ITEM #3 - DAIRY HILL SUBDIVISION ADDITION NO 1

KPB File No.	2023-057
Plat Committee Meeting:	June 12, 2023
Applicant / Owner:	Leirer Family Limited Partnership of Seward, Alaska
Surveyor:	Joshua Varney / Lounsbury & Associates Inc
General Location:	Phoenix Road, Bayview Place, Aialik Street, Dairy Hill Lane, Third Avenue, and Seward Highway, City of Seward

STAFF REPORT

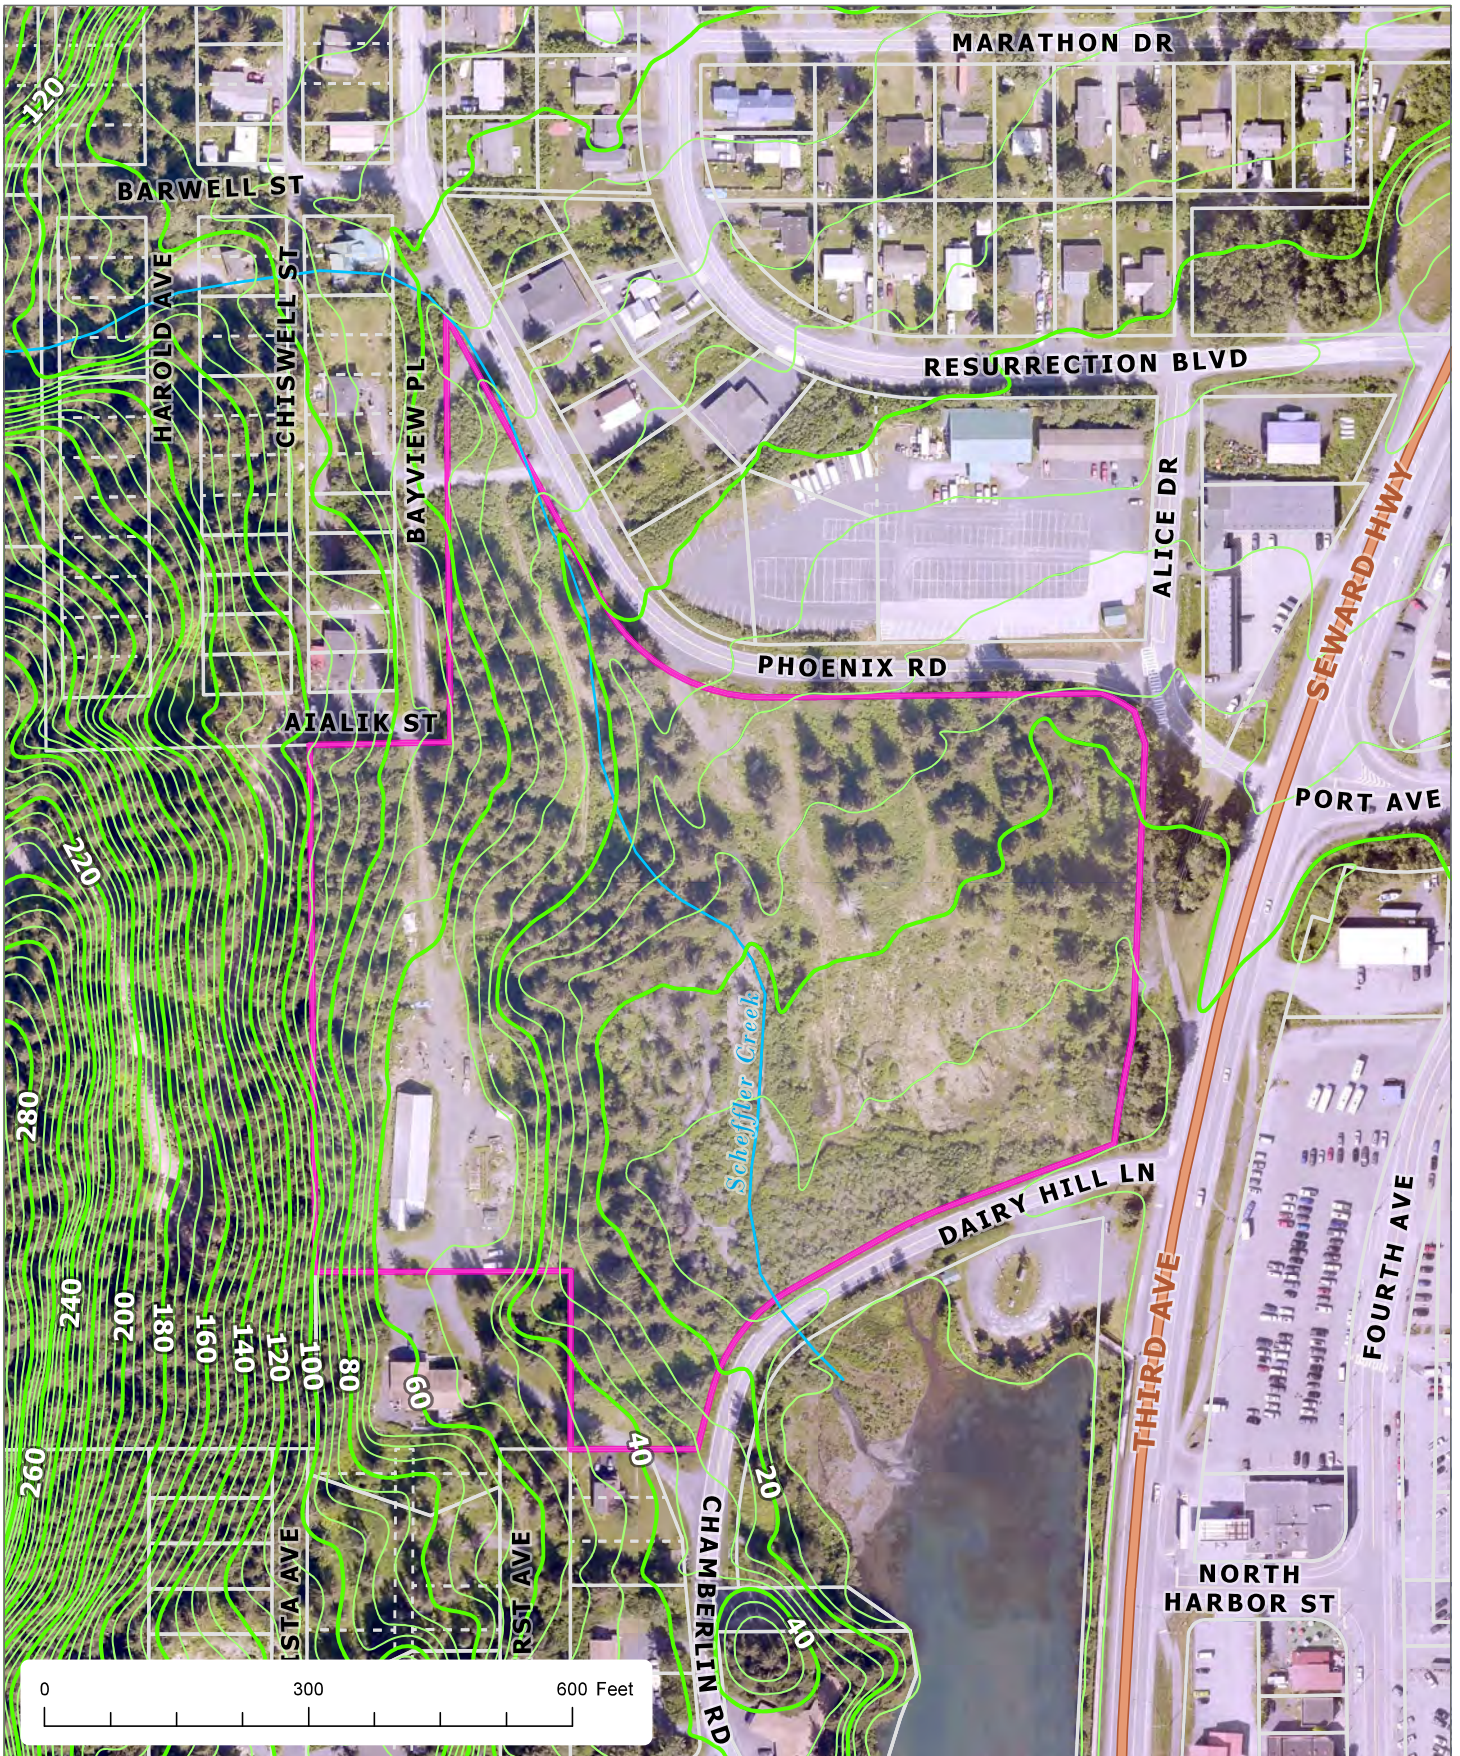
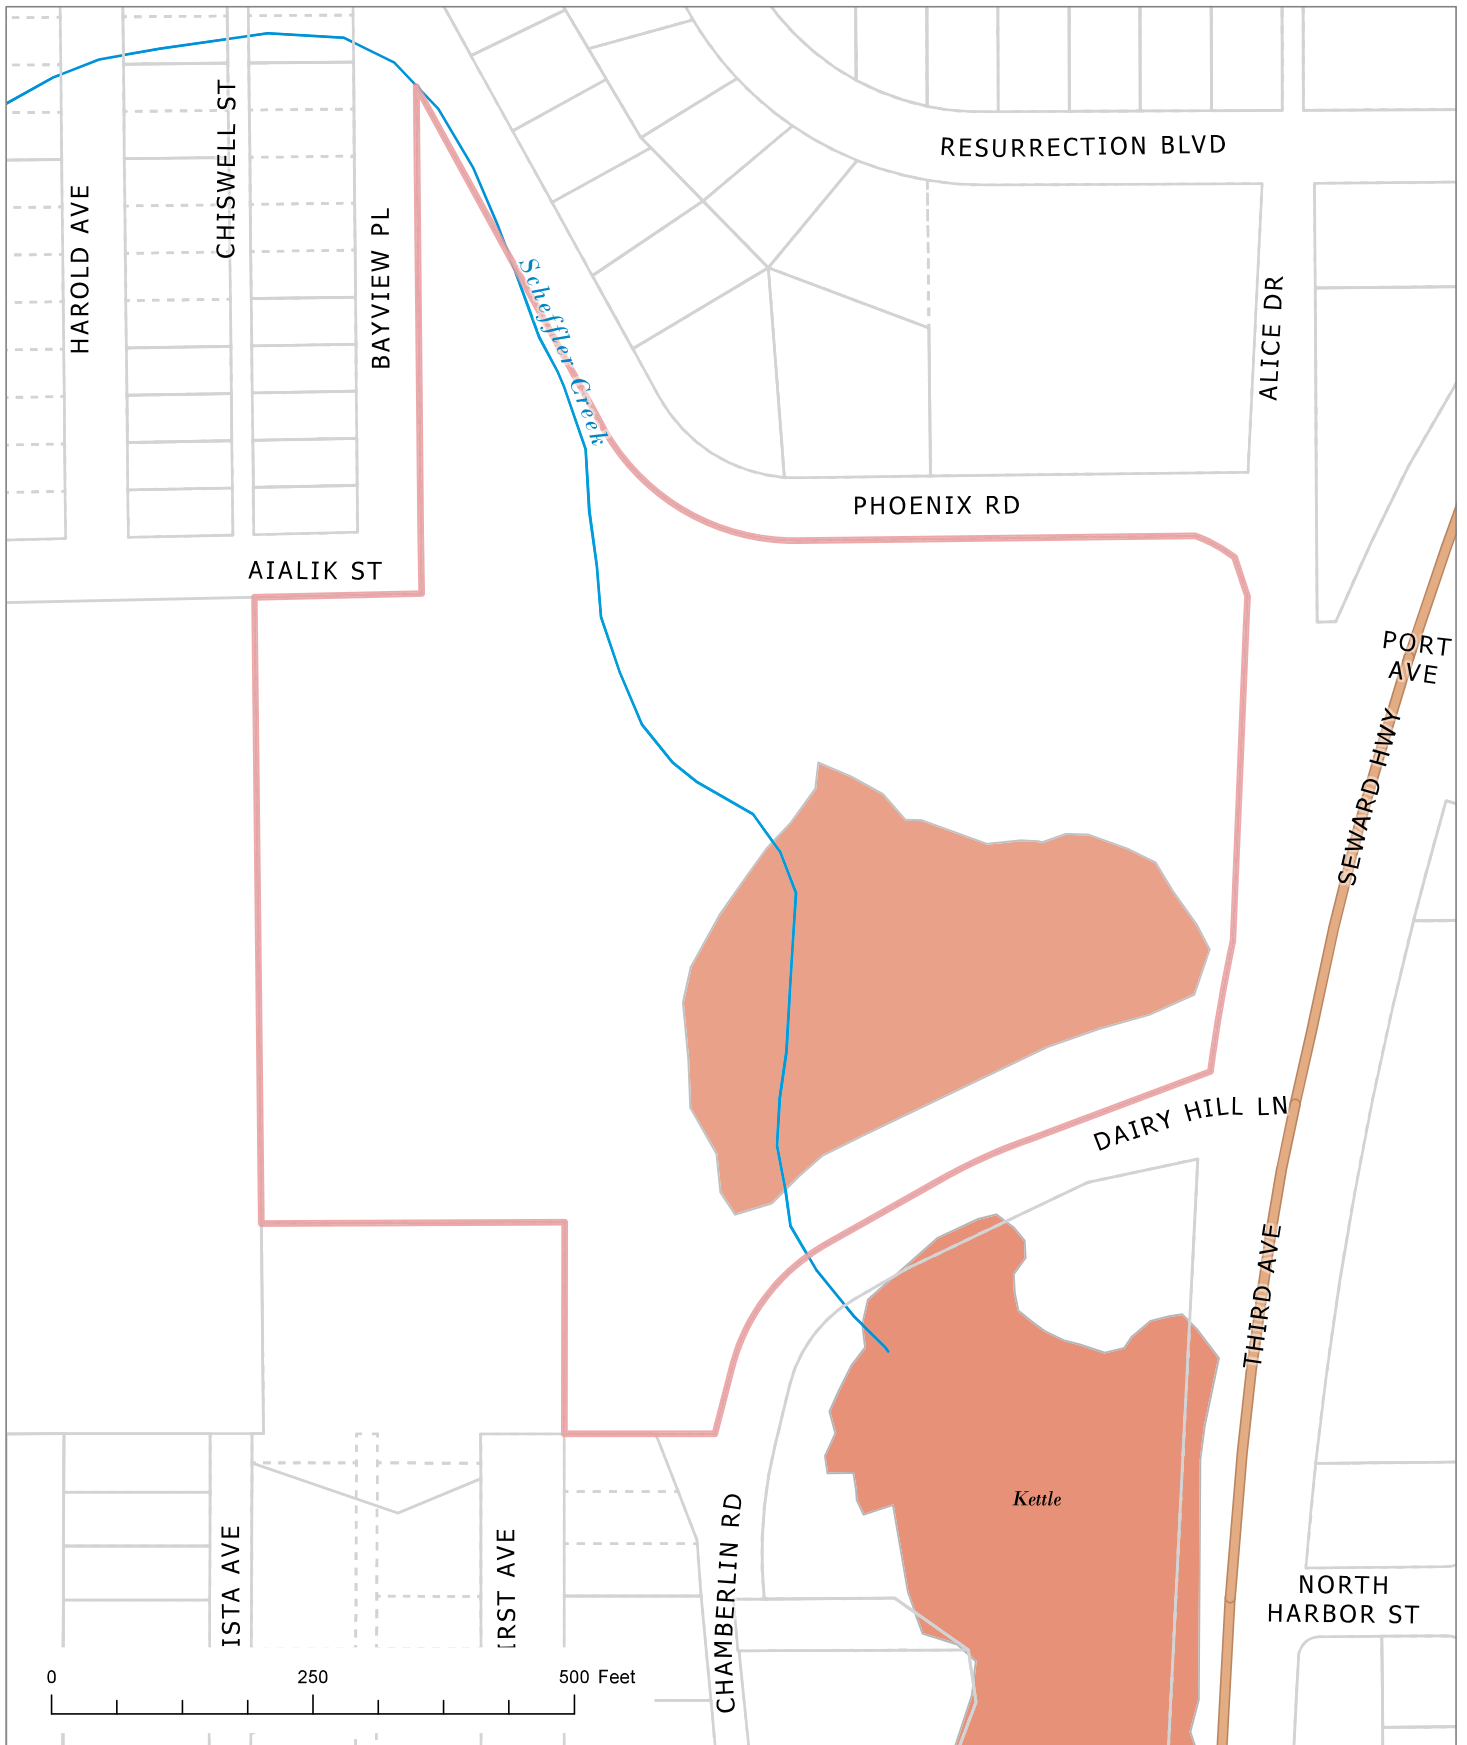
The plat is also proposing a dedication of the intersection of Bayview Place and Phoenix Road to take the pointed portion off where driving is occurring. **Staff recommends:** *applying curves to the ends at each street to smooth the turning.*

The western side of the plat has some steep slopes shown by the topography on the plat. **Staff recommends:** *showing top and toe of steep slopes over 20% on the final.*

- Add KPB file number 2023-057 to drawing.
- Lot labels, blocks, subdivision designations need updated throughout.
- Carry over plat notes from parent plat that apply.
- L4 is missing from the table.
- Lot labels and subdivision labels should carryover to page 2.

- Staff recommendation:** *include NE ¼ of Section 4 to the legal description.*
- C. The location, width, and name of existing or platted streets and public ways, railroad rights-of-way, and other important features such as section lines or political subdivisions or municipal corporation boundaries abutting the subdivision;

- Staff recommendation:** *Source information for Seward Highway, other streets need ROW width added.*
- D. A vicinity map, drawn to scale showing location of proposed subdivision, north arrow if different from plat orientation, township and range, section lines, roads, political boundaries, and prominent natural and manmade features, such as shorelines or streams;

- Staff recommendation:** *The Chugach Forest should be labeled.*
- G. The status of adjacent lands within 100 feet of the proposed subdivision boundary or the land status across from any dedicated rights-of-way that adjoin the propose subdivision boundary, including names of subdivisions, lot lines, block numbers, lot numbers, rights-of-way; or an indication that the adjacent land is not subdivided;

- Staff recommendation:** *several lots are missing correct plat numbers and block designations. These will need to be added.*

- A. Streets designed to have one end permanently closed shall be no more than 1000 feet long. The closed end of the cul-de-sac shall have a suitable turnaround with a minimum radius of 50 feet to the property line. The turnaround shall be constructible to a 4 percent grade or less. **Staff recommendation:** *depict the minimum 50 foot radius for cul-de-sac portion of the proposed Bayview Place dedication.*
